3.2 Bloom Street

4.0 Design Changes

4.1 List of Design Changes

4.2 Space planning and compliancy

Bloom Street. Second Floor

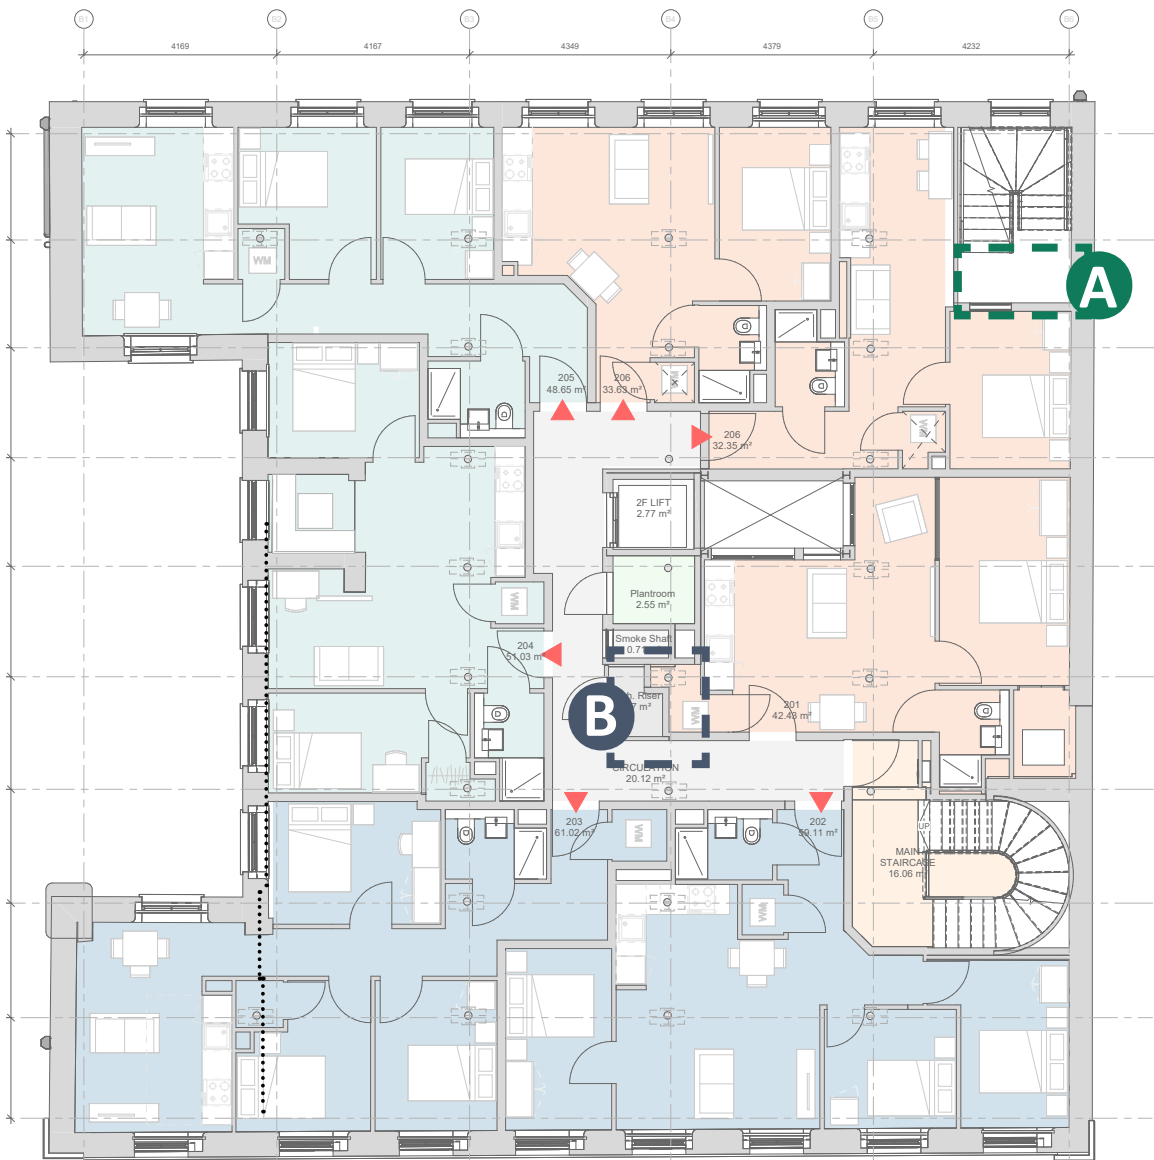
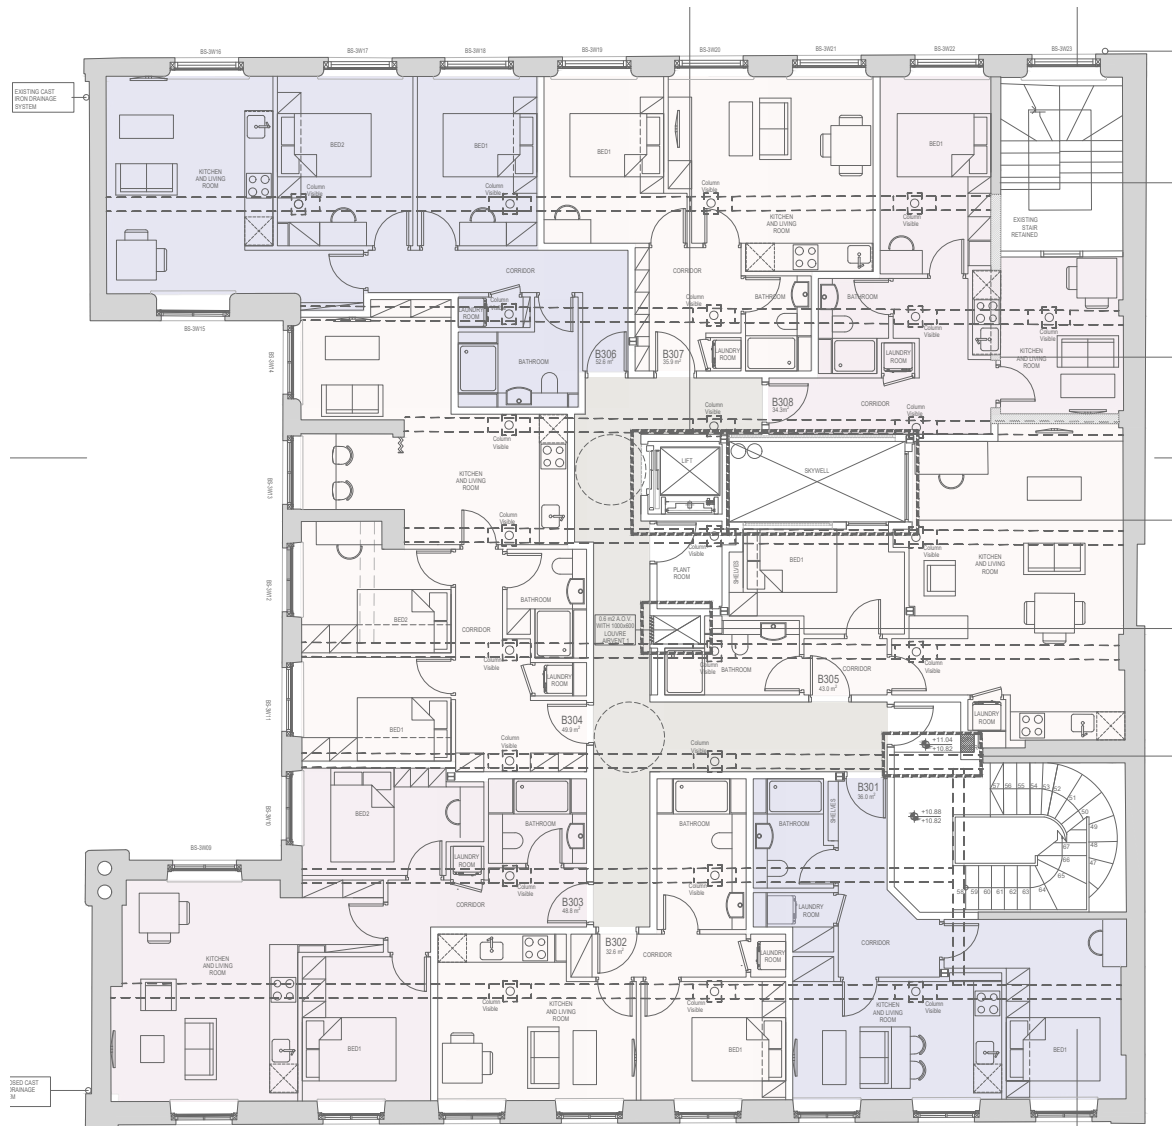
- Apartment layout: Improved efficiency and open plan arrangement where possible.
- New structural columns: Removal of 6x proposed steel H columns following structural proposal review.
- Main stair handrail: to be upgraded to comply with minimum height requirement. Additional top rail required possibly without interfering with original balustrade

Rear stair landing: proposed for access ad maintenance (was removed in later GAs versions)

Plantroom: Mechanical plant added for functional reasons.

Bloom Street. Third Floor

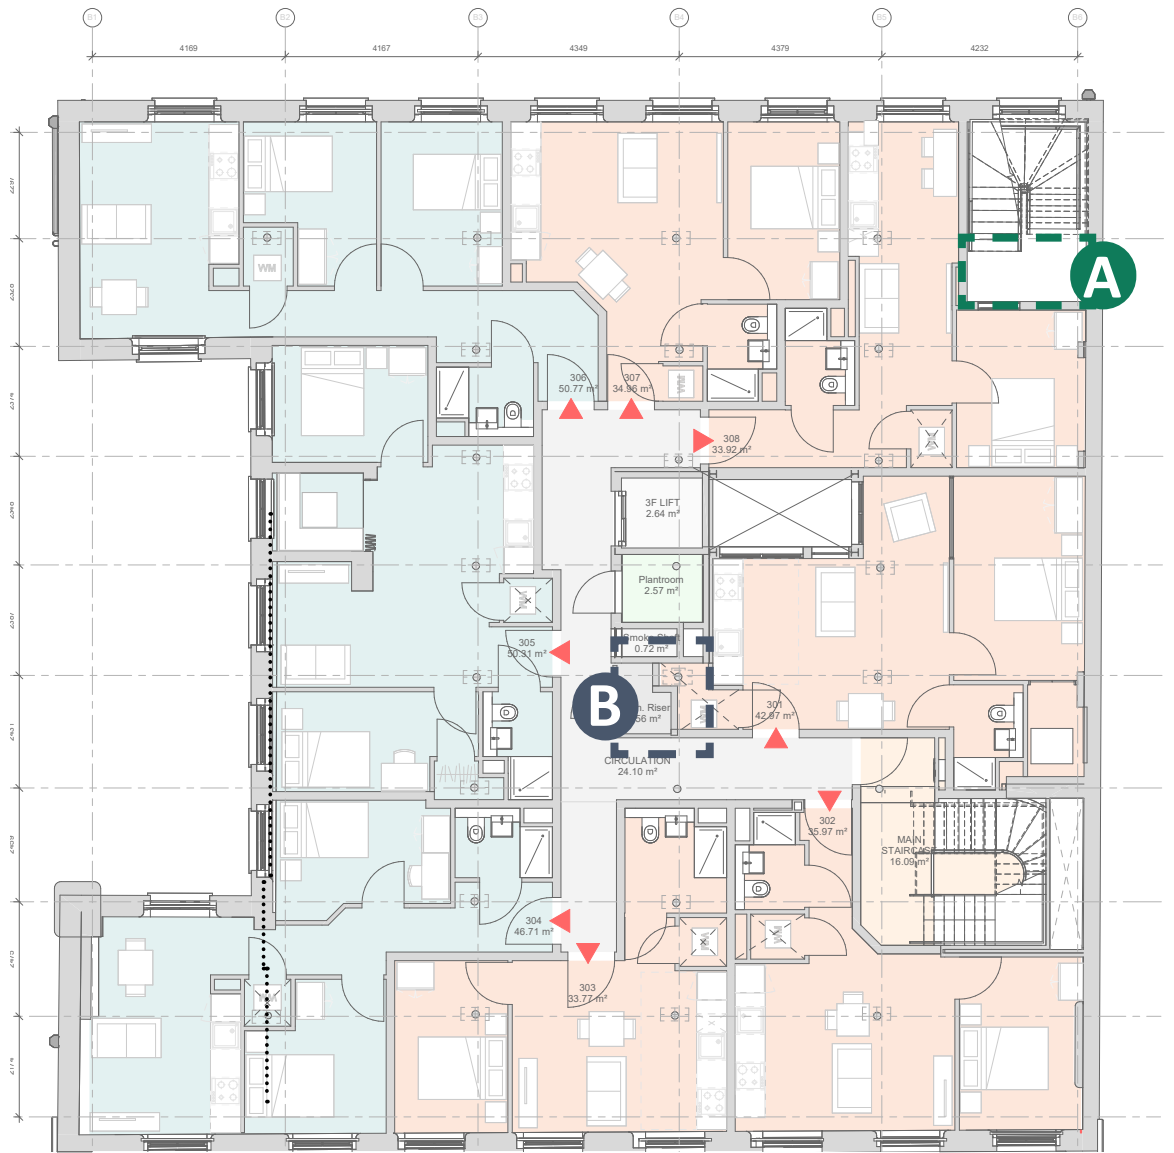
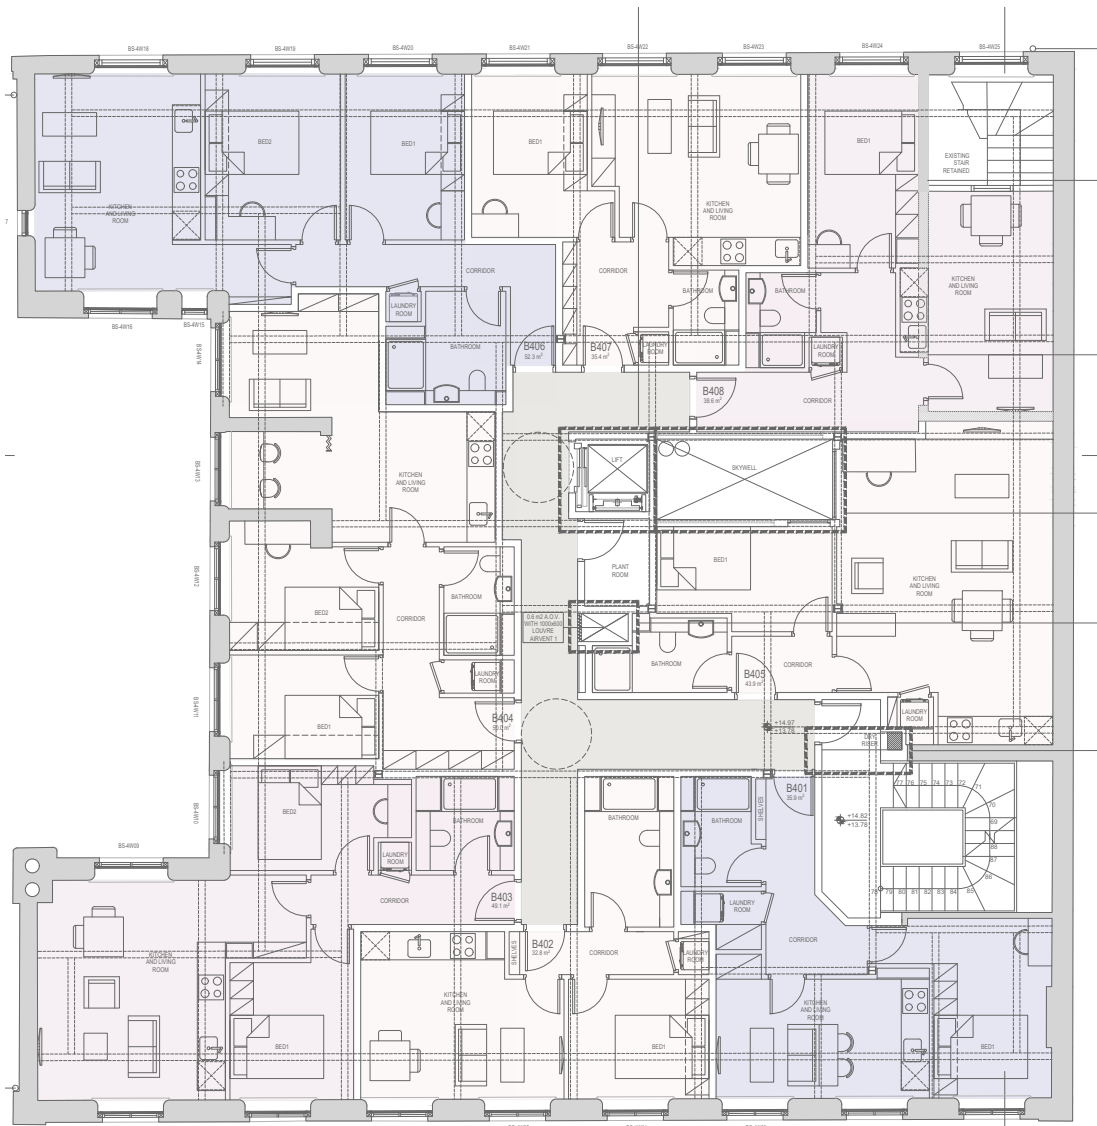
- Apartment layout: Improved efficiency and open plan arrangement where possible.
- New structural columns: Removal of 6x proposed steel H columns following structural proposal review.

Rear stair landing: proposed for access ad maintenance (was removed in later GAs versions)

Plantroom: Mechanical plant added for functional reasons.

Bloom Street. Fourth Floor

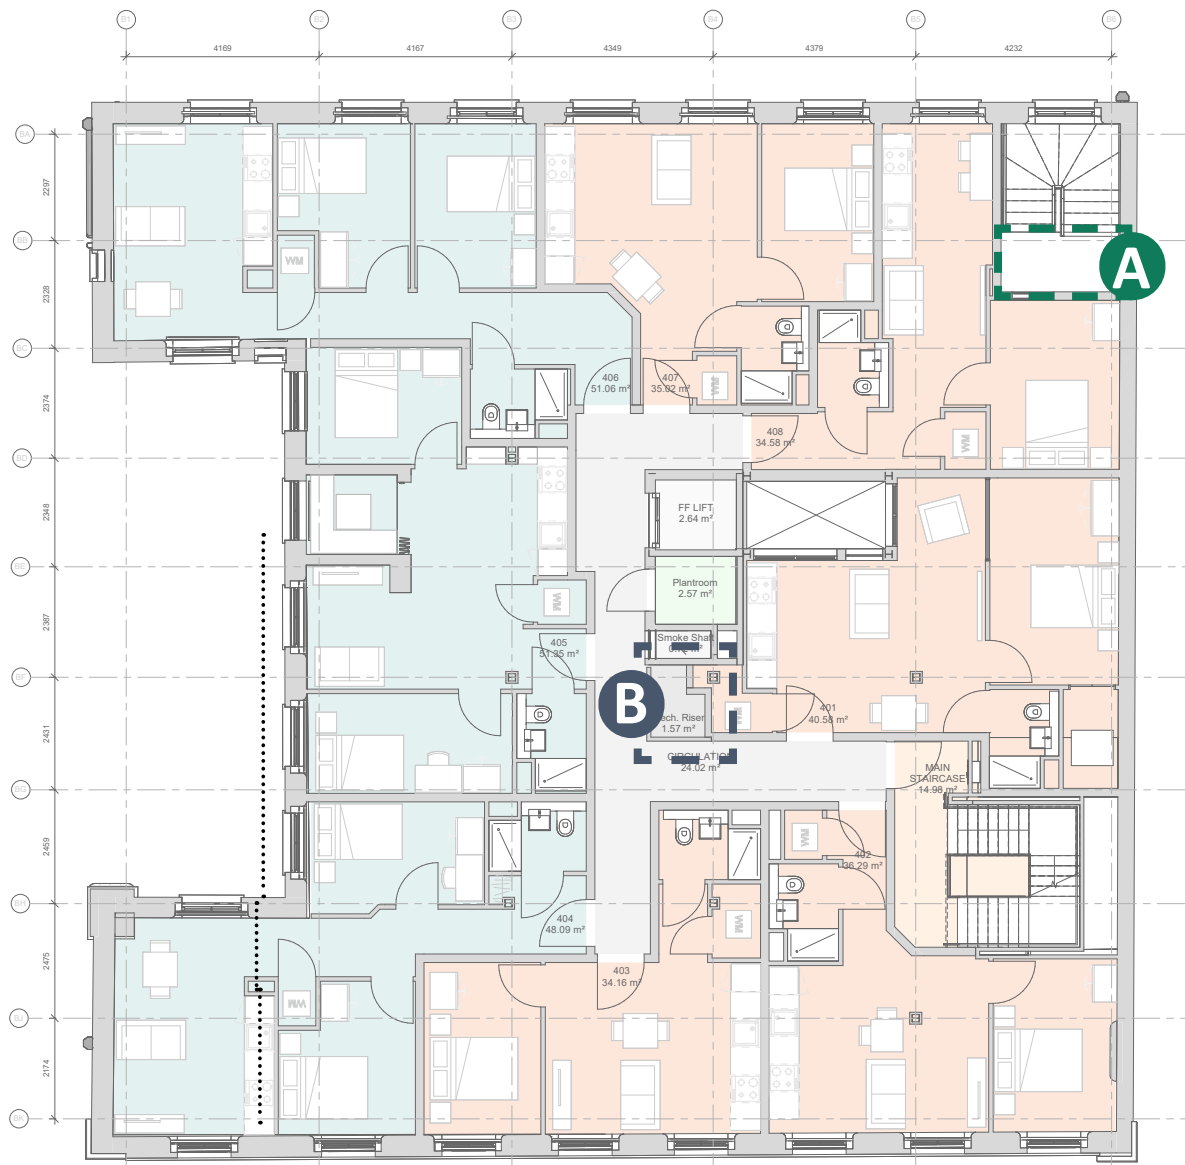
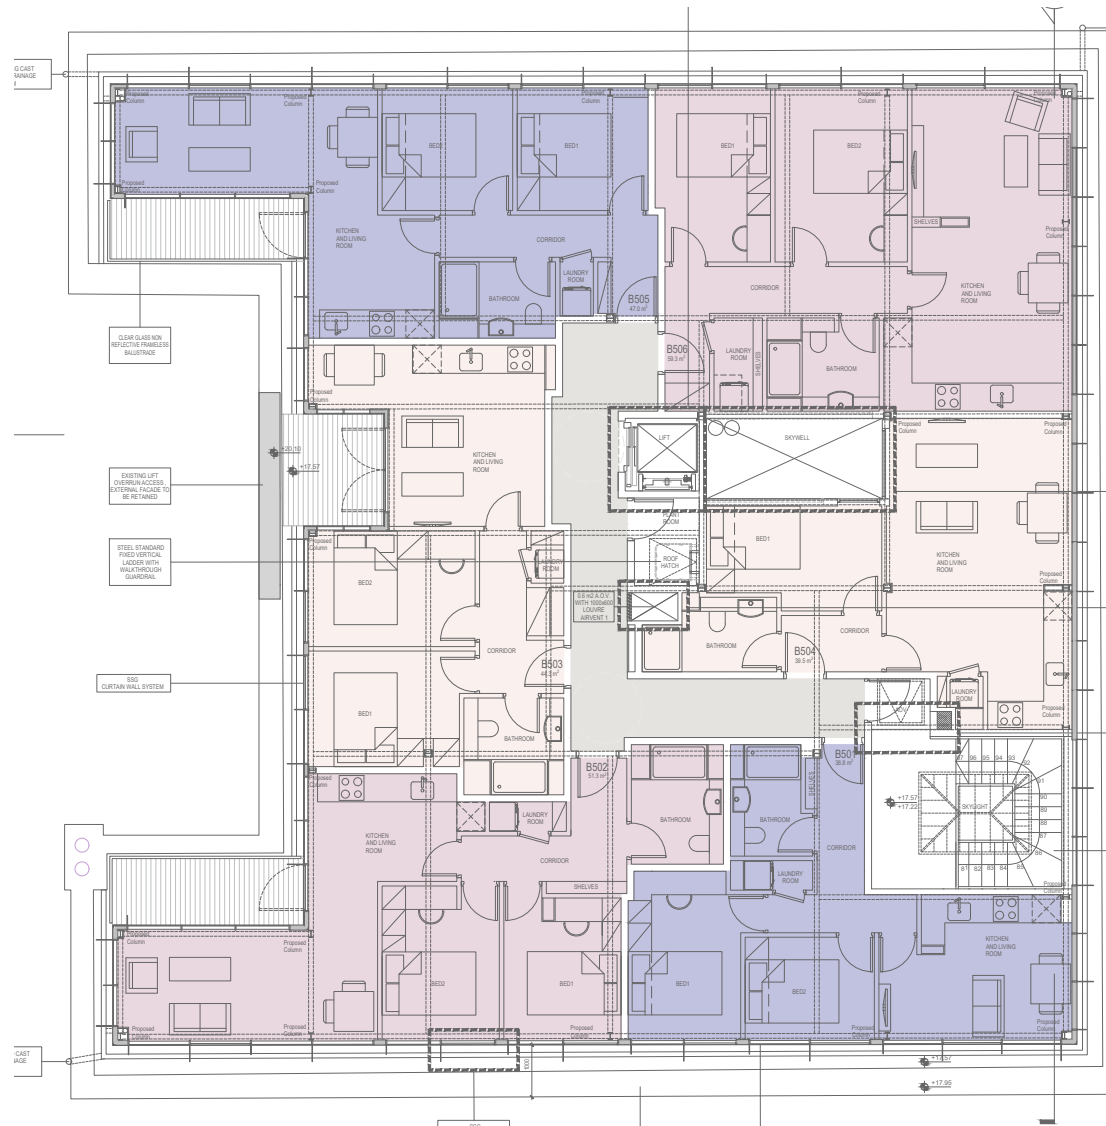
- Apartment layout: Improved efficiency and open plan arrangement where possible.
- New structural columns: Following structural reviews, it is proposed to remove 6x proposed steel H columns and locate 7x new proposed steel H columns aligned to existing structure.

- A** Rear stair landing: proposed for access and maintenance (was removed in later GAs versions)
- B** Plantroom: Mechanical plant added for functional reasons.

Bloom Street. Fifth Floor

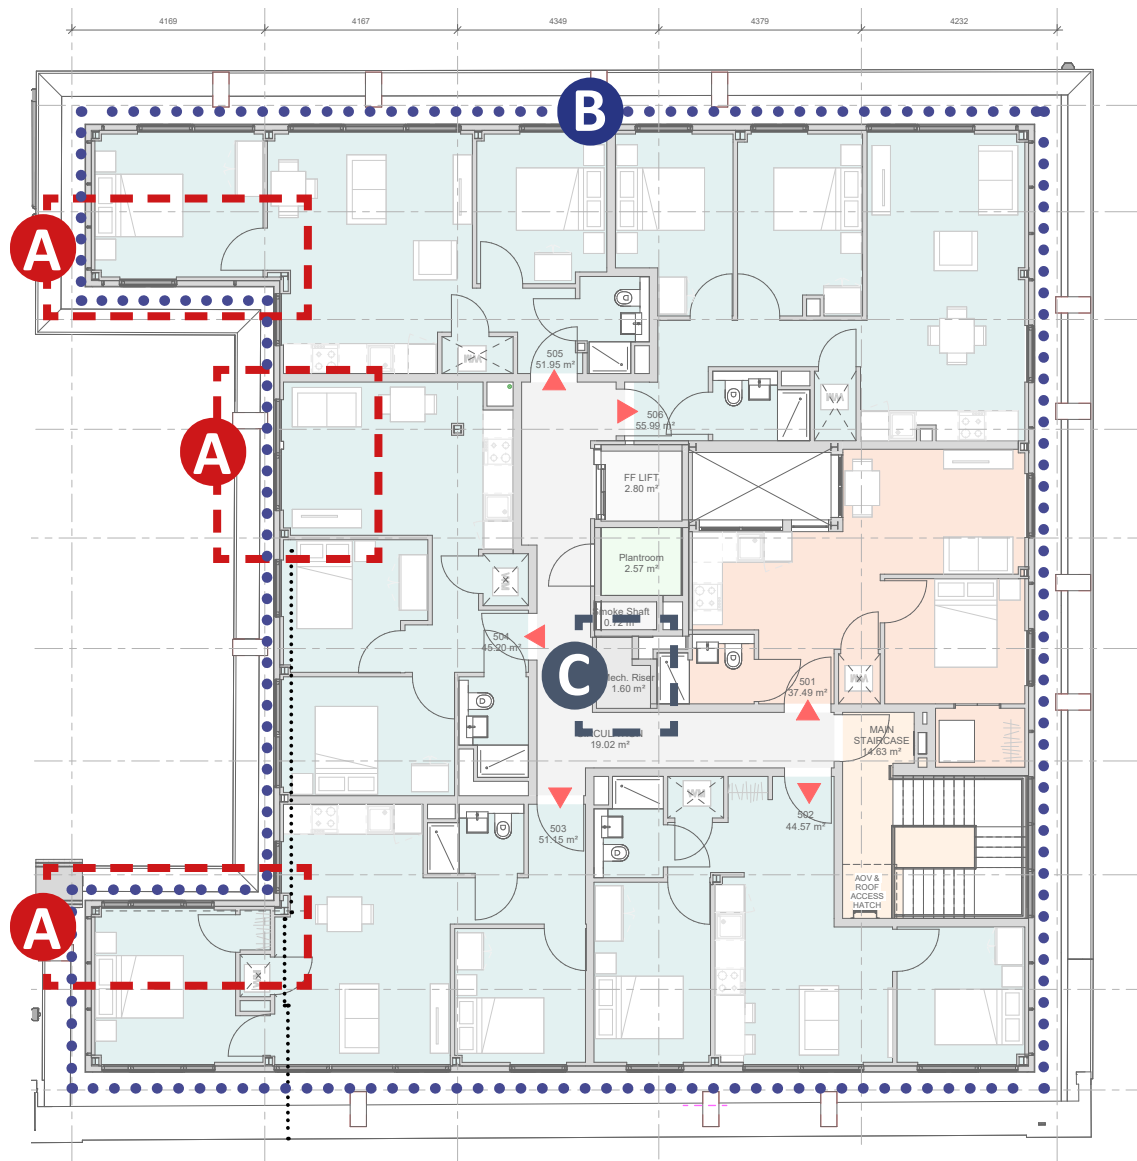
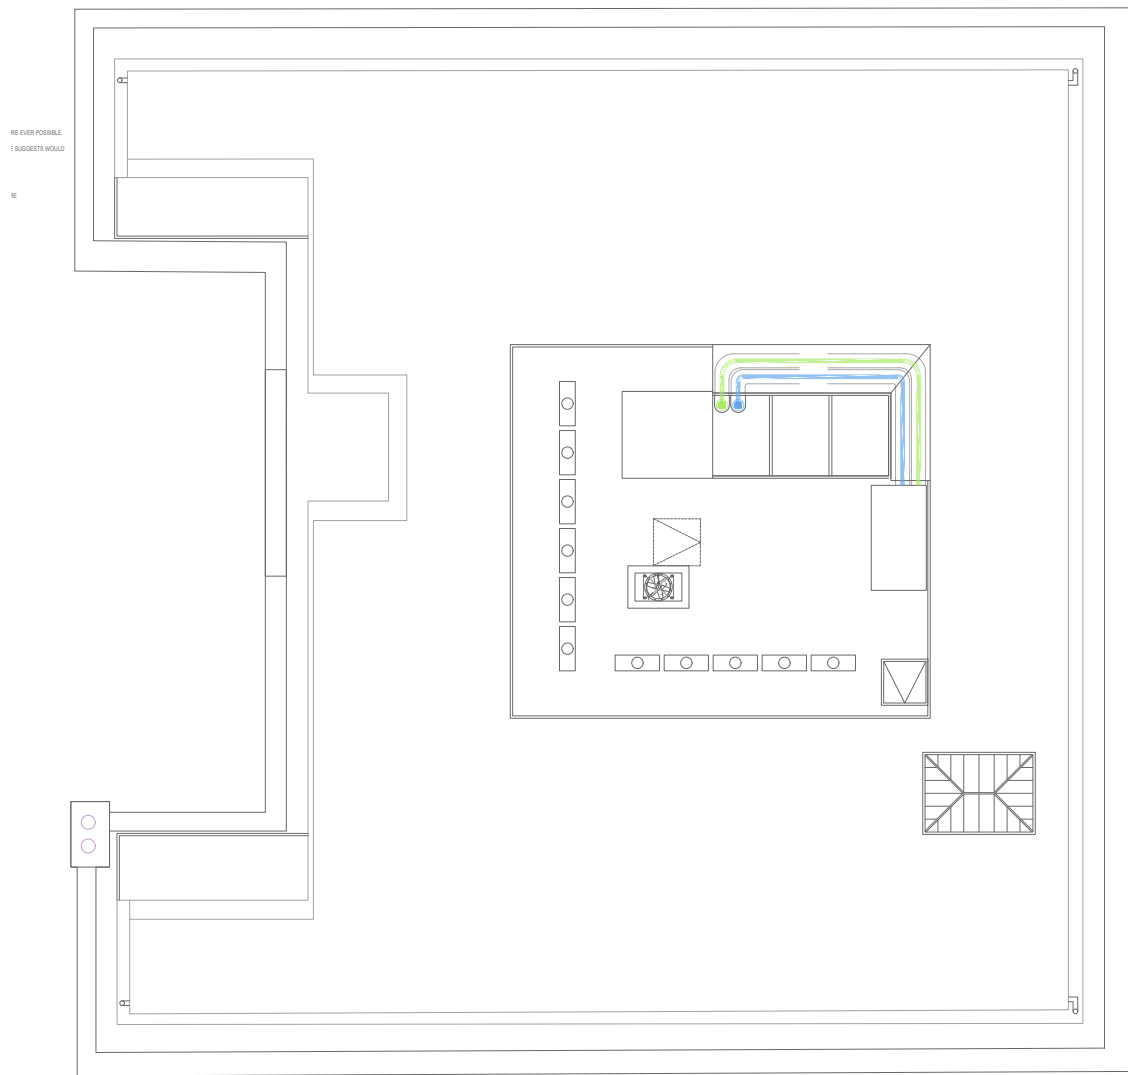
- Apartment layout: Improved efficiency and open plan arrangement where possible.
- New structural columns: Relocation of steel H columns supporting new floor above following structural proposal review.

- A** Small terraces: Proposed to be removed to improve apartment internal layouts arrangements. Spasce was generally too tight to be functional.
- B** Glazed vertical fins: removed from proposal. Fixing detail proved to be difficult to achieve an aesthetic satisfactory quality and are an issue for maintenance of the area. A clean, solid glazed extension is the new proposal.
- C** Plantroom: Mechanical plant added for functional reasons.
